**To:** Kristopher Byrd, Well Construction Manager  
**From:** Tommy Laird, Well Construction Program Coordinator  
**Subject:** Review of Water Right Application G-19199  
**Date:** June 3, 2024

# Groundwater Application Review Summary Form

Application # G- 19199

TO: Water Rights Section Date 10/24/2022  
 FROM: Groundwater Section James Hootsmans/Travis Brown/Justin Iverson  
 Reviewer's Name  
 SUBJECT: Application G- 19199 Supersedes review of 4/6/2022  
 Date of Review(s)

### Water-Level Measurements in Nearby Wells

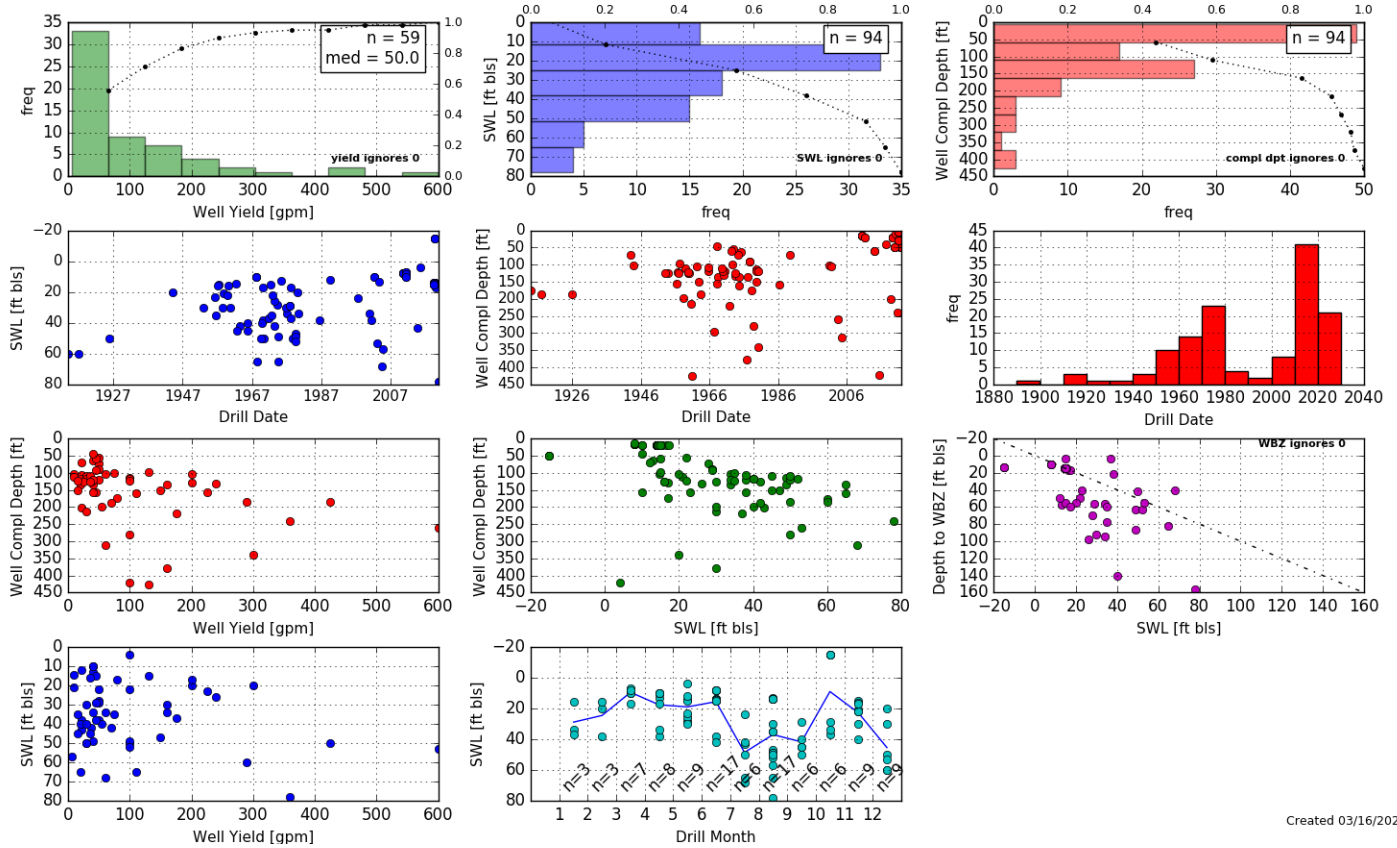
**Basis for aquifer hydraulic connection evaluation:** The elevation of groundwater in nearby observation wells with comparable construction to the proposed POA is similar to the elevation of nearby surface water (see Hydrograph, attached). Groundwater surface mapping in this area indicates that groundwater is generally flowing towards the small streams and reservoirs which drain into Rock Creek (Gannett and Caldwell, 1998).

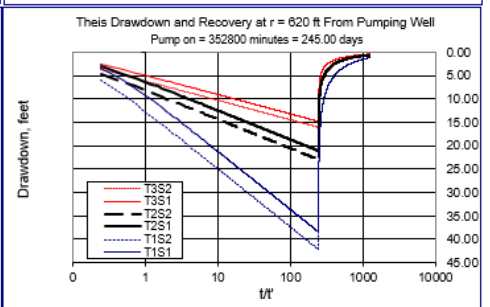
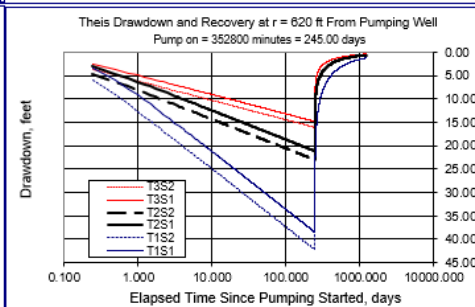
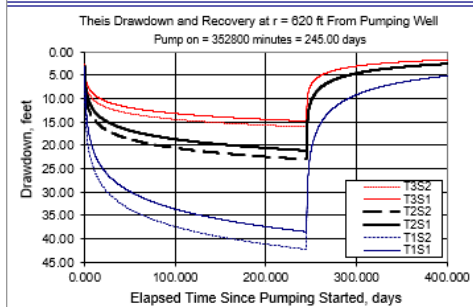
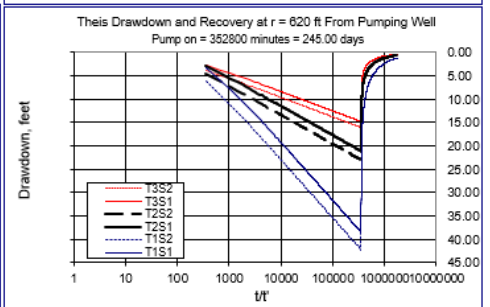
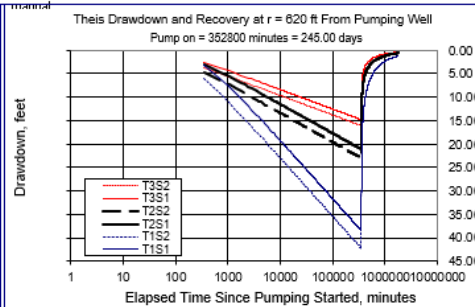
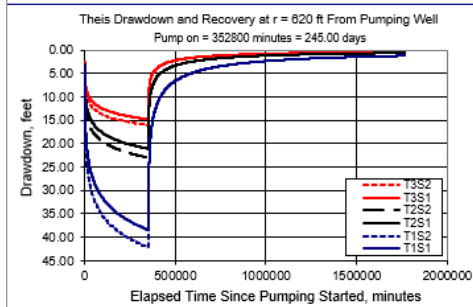
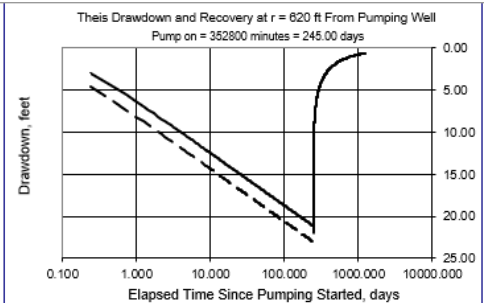
A Theis (1935) drawdown analysis was conducted to assess the potential well-to-well interference with CLAC 2538 due to pumping of the proposed POA in the amounts requested. Hydraulic parameters used for the analyses were derived from regional data and studies (Pumping Test Reports; Conlon et al., 2003, 2005; Iverson, 2002; Woodward et al., 1998) or are within a typical range of values for the parameter within the hydrogeologic regime (Freeze and Cherry, 1979).

Results indicate that the proposed use is not likely to cause well-to-well interference with CLAC 2538 that exceeds the threshold under the standard condition for alluvial aquifers in the Willamette Basin.
